UNITED STATES PATENT AND TRADEMARK OFFICE

10/586,110

Office Action Summary	Application No. 10/586,110	Applicant(s) TILLMANN, HORST	
	Examiner ROBERTA DELISLE	Art Unit 3677

DETAILED ACTION

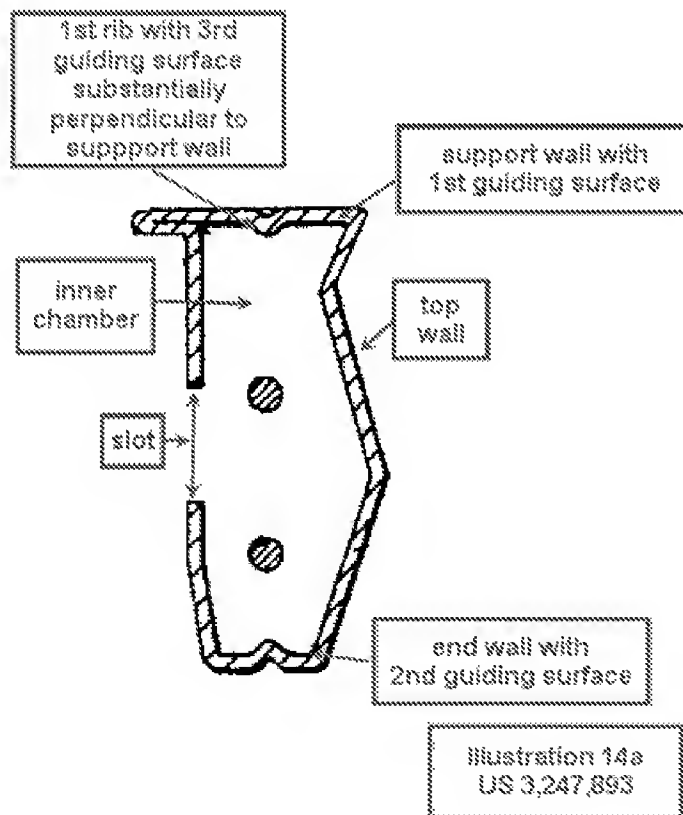
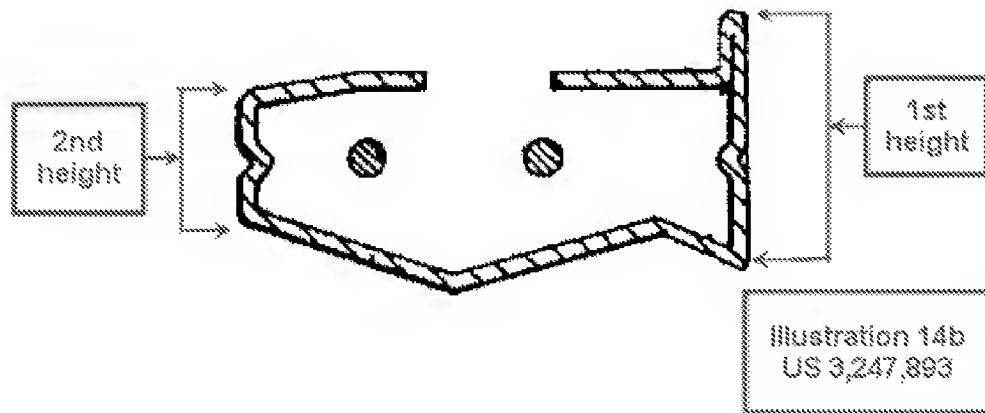
With respect to the arguments pertaining to independent claim 14, "...the first longitudinal rib having a third guiding surface extending substantially perpendicularly to the first guiding surface..." Examiner maintains that the rib on the upper supporting wall, shown in Illustration 14a below, has a guiding surface that is substantially perpendicular to the supporting wall.

broadest interpretation of the drawings. In this case, the small rib on the upper ridge of Ford meets the limitations of the claims. Also, it would be a matter of design choice to provide a larger or smaller surface area on the rib.

wherein the support wall has a first height, the end wall having a second height which is less than the first
height (See Illustrations 14a & 14b below)

Examiner notes that Ford discloses a rib on an upper support wall and considers it to be substantially perpendicular to the support wall.

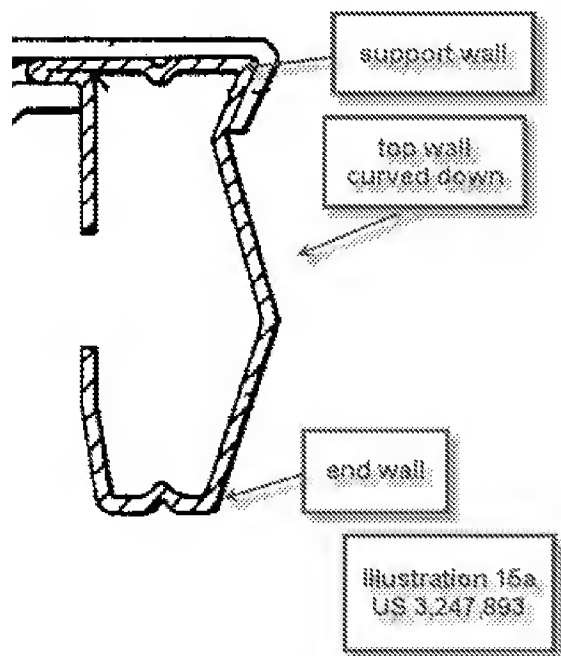
(Previously Presented) The slide channel of claim 14, wherein the top wall is downwardly curved from the support wall toward the end wall (See Illustration 15a below)

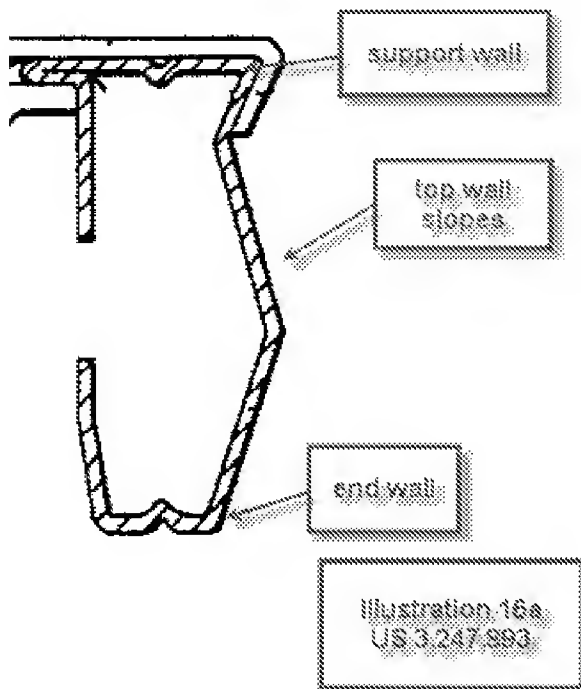
(Previously Presented) The slide channel of claim 14, wherein the top wall slopes from the support wall toward the end wall **(See Illustration 16a below)**

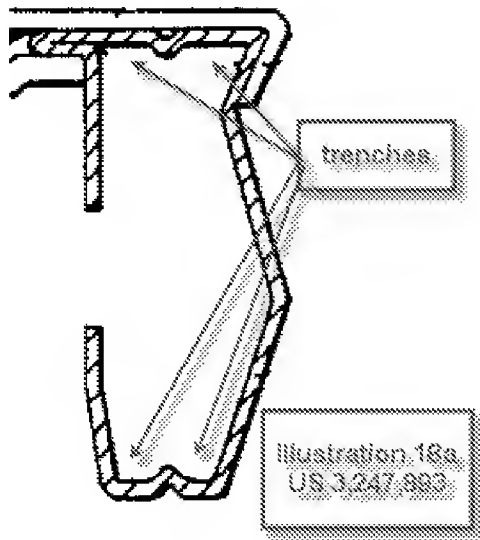
(Previously Presented) The slide channel of claim 14, wherein the support wall has at least one trench **(See Illustration 18a below)**

(Previously Presented) The slide channel of claim 14, wherein the top wall has at least one trench (See Illustration 18a in claim 18)

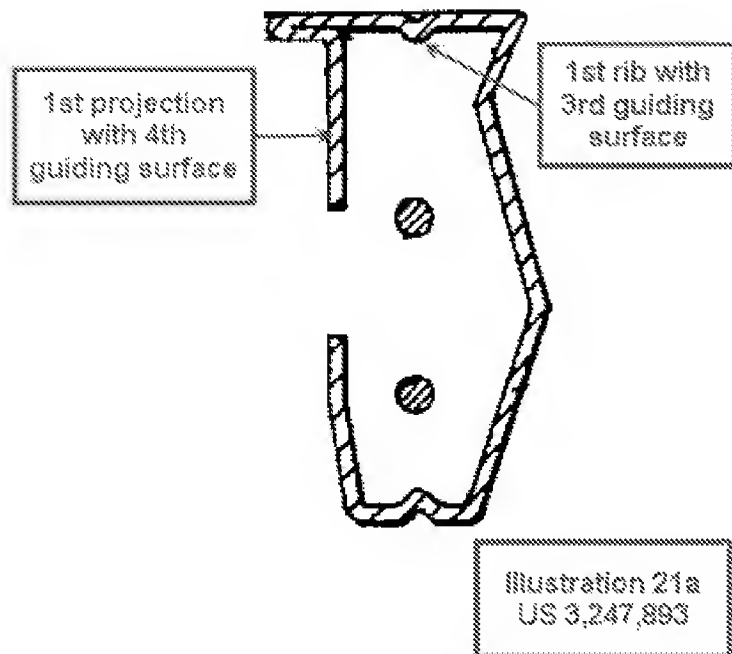
(Currently Amended) The slide channel of claim ~~[[20]]~~ **14**, wherein the support wall further comprises a first projection extending over the entire length of the housing (**figure 2**) ~~and projecting into the inner chamber~~, the first projection having a **fourth guiding** surface which forms a second guiding surface of the plurality of guiding surfaces, the second guiding surface being **is** opposite and parallel to the first **third** guiding surface **on the first longitudinally rib** (See Illustration 21a below)

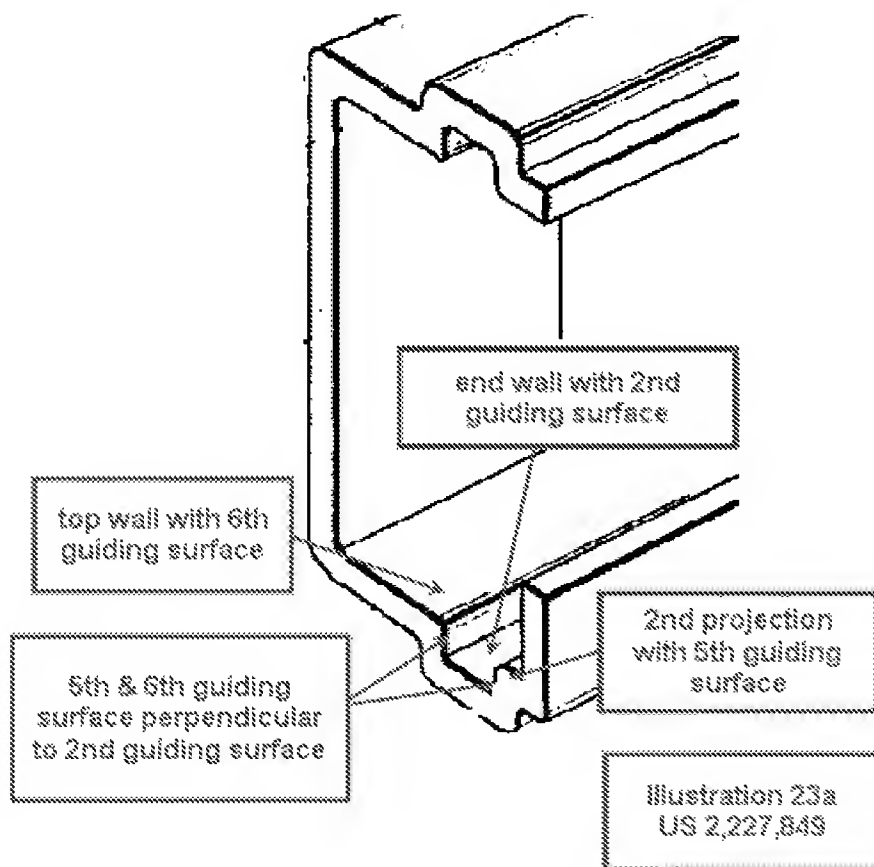
(Currently Amended) The slide channel of claim [[22]] 21, wherein the end wall comprises a second projection extending over the entire length of the housing (**figure 2**) and projecting into the inner chamber, the second projection having a surface which forms a fourth fifth guiding surface and of the plurality of guiding surfaces, wherein the top wall has a surface which forms a fifth sixth guiding surface of the plurality of guiding surface, and wherein the end wall further has a surface which forms a sixth guiding surface of the plurality of guiding surface, the fourth and fifth guiding surfaces facing each other and the fifth and sixth guiding surfaces being perpendicular to the six second guiding surface of the end wall. (See Illustration 23a below)

Examiner notes that Ford discloses a slide channel. Soss teaches a slide channel with perpendicular guiding surfaces. This configuration provides more stability to the slide member in the slide channel. It would have been obvious to one having ordinary skill in the art at the time of the invention to modify Ford with a slide channel having perpendicular guiding surfaces as taught by Soss to provide more stability to the slide member in the slide channel.

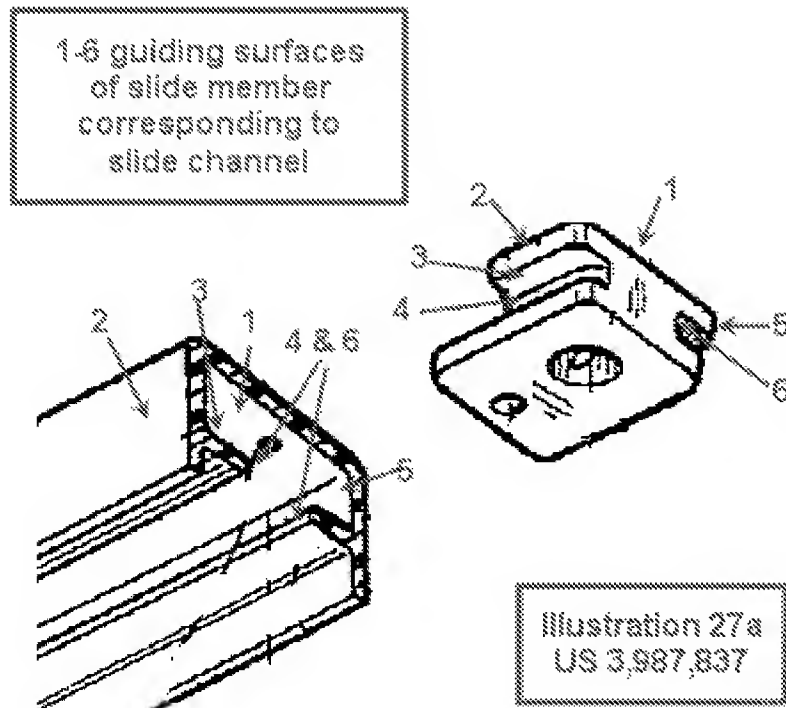
(New) A slide rail assembly comprising a slide channel of claim 23 and a slide member [*connectable to an actuating arm of a door closer*]*, the slide member **(62)** having a slide channel contour with a plurality of supporting surfaces corresponding to the first through sixth guiding surfaces of the slide channel **(38)**, the slide member **(62)** comprising a base wall **(64)** which matches a contour of the housing of the slide channel **(38)** **(See Illustration 27a below)**

Examiner notes that Ford as modified by Soss discloses a slide channel. Hewson teaches a slide member & slide channel with matching contours. The use of matching contoured components provides a more secure connection between the components since more surface area is being contacted. It would have been obvious to one having ordinary skill in the art at the time of the invention to modify Ford with a slide channel & slide member having matching contours as taught by Hewson to provide a secure connection between the components.

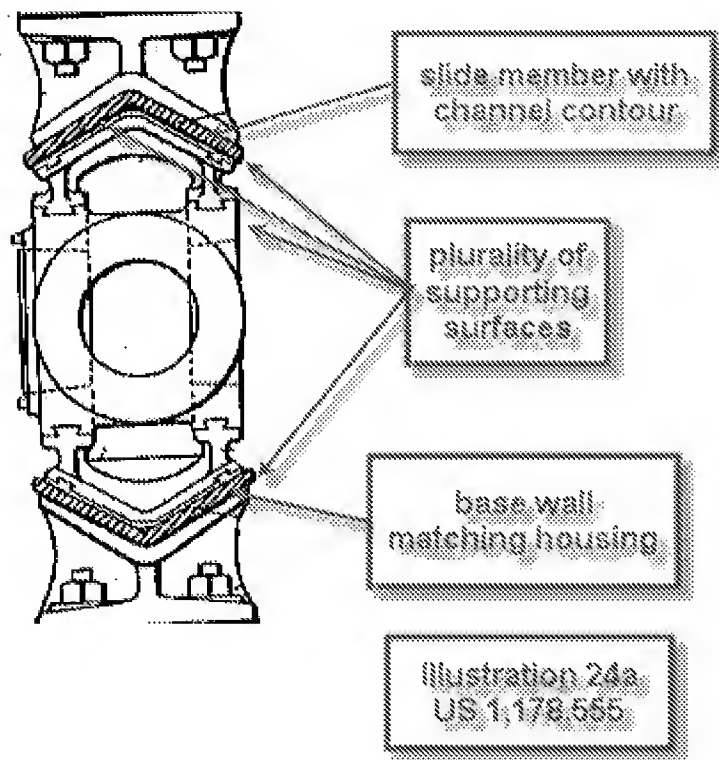
(Currently Amended) A slide member for the rail assembly comprising a slide channel of claim 14 and a slide member [connectable to an actuating arm of a door closer]*, the slide member having a slide channel contour with a plurality of supporting surfaces, the slide member (**figure 2**) comprising a

base wall (11) which matches a contour of the housing of the slide channel (7a, 15a) (See Illustration 24a below)

Examiner notes that Ford discloses a slide channel. Thomson teaches a slide member with contoured bases that match a contoured housing. The use of matching contoured components provides a more secure connection between the components since more surface area is being contacted. It would have been obvious to one having ordinary skill in the art at the time of the invention to modify Ford with contoured mating surfaces as taught by Thomson to provide a secure connection between the components.

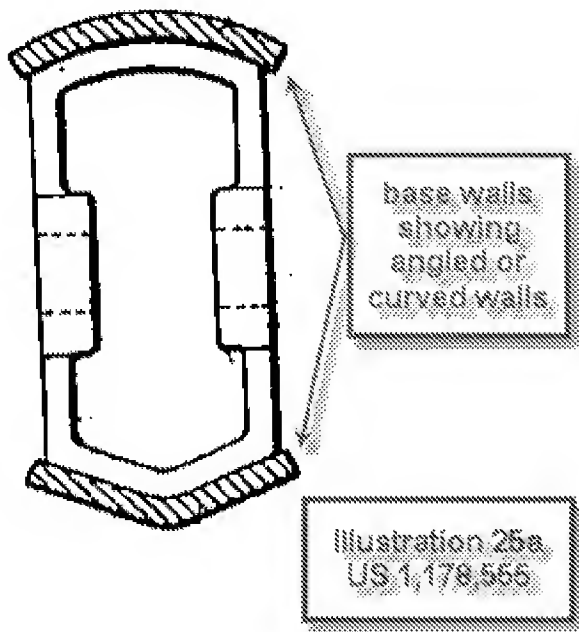
(Currently Amended) The ~~slide member~~ rail assembly of claim 24, wherein the base wall (11) comprises two partial walls which are disposed at an angle with each other (See Illustration 25a below)

Examiner notes that Ford discloses a slide channel. Thomson teaches a slide member with angled base walls. The angled base walls provide a more secure connection between the components since more surface area is being contacted. It would have been obvious to one having ordinary skill in the art at the time of the invention to modify Ford with angled mating surfaces as taught by Thomson to provide a secure connection between the components.

(Currently Amended) The ~~slide member~~ rail assembly of claim 24, wherein the base wall (11) has a curved shape (See Illustration 25a in claim 25)
